Access Compliance Report

Public Rights-of-Way

(Curb Ramps)

Intersection ID: 51075	Main Street: MORTEMER_LN	Cross Street: SILVER_GLEN_LN	Location: SE
ADA ID: 95EDBF7EC70B	Ramp Type: PerpDiag	Initial Pass/Fail: Fail	Overall Compliance: No
Codes/Mitigation Info/Possible Solution		Field Measurements/Component Compliance	
Severity Score: 58.75

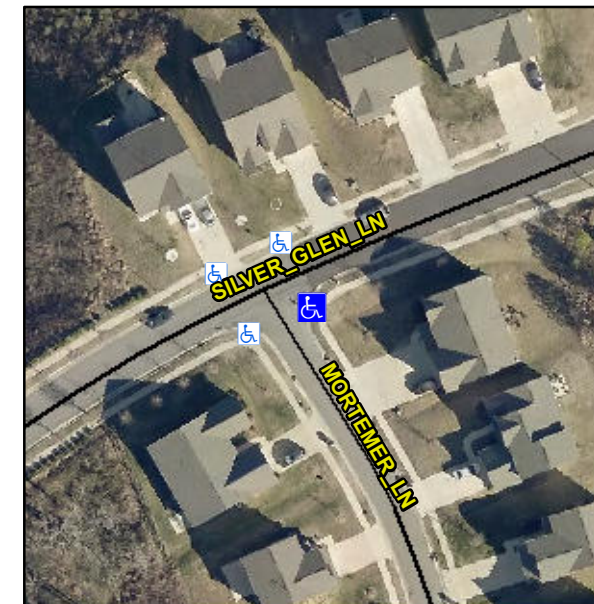
Not Found, R304.5.1, R304.2.2, R304.5.3

Compliance	Description	Data	Compliance	Description	Data
N/A	Ramp Length (in)	49.0	No	Ramp Slope (%)	13.5
No	Ramp Width (in)	44.0	No	Ramp XSlope (%)	9.2
N/A	Flare Type LT	N/A	N/A	Flare Type RT	N/A
N/A	Flare Slope LT (%)	N/A	N/A	Flare Slope RT (%)	N/A
N/A	Flare Traversable LT?	N/A	N/A	Flare Traversable RT?	N/A
N/A	Landing Length (in)	N/A	N/A	DWS Provided?	N/A
N/A	Landing Width (in)	N/A	N/A	DWS Contrast?	N/A
N/A	Landing Slope (%)	N/A	N/A	DWS Length (in)	N/A
N/A	Landing X Slope (%)	N/A	N/A	DWS Full Width?	N/A
N/A	Landing Curb? (Y/N)	N/A	N/A	DWS Offset (in)	N/A
N/A	Shared Landing?	N/A			
N/A	Gutter Ponding?	N/A	N/A	Gutter Slope (%)	N/A
N/A	Gutter Lip Ht (in)	2.0	N/A	Gutter X Slope (%)	N/A
N/A	Painted X Walk1?	No	N/A	Painted X Walk2?	No
	X Walk 1 Direction	To N		X Walk 2 Direction	To W
N/A	X Walk 1 Width (in)	N/A	N/A	X Walk 2 Width (in)	N/A
	X Walk 1 Slope (%)	1.8		X Walk 2 Slope (%)	5.3
	X Walk 1 X Slope (%)	9.1		X Walk 2 X Slope (%)	4.7

N/A	Ramp inside XWalk1?	N/A	N/A	Ramp inside XWalk2?	N/A
	Road Slope (%)	10.3	N/A	Clear Space?	N/A
	Road X Slope (%)	4.2	N/A	Clear Space to XWalk (in)	N/A
N/A	Any Obstructions?	N/A	N/A	Storm Grate/Utility Hazard?	N/A
	Obstruction Type			Storm Grate/Utility Type	
		N/A			N/A
			Yes	Surface Condition? (G/P)	Good

Remove & Replace Curb Ramp With Two New Directional Ramps or Equivalent.
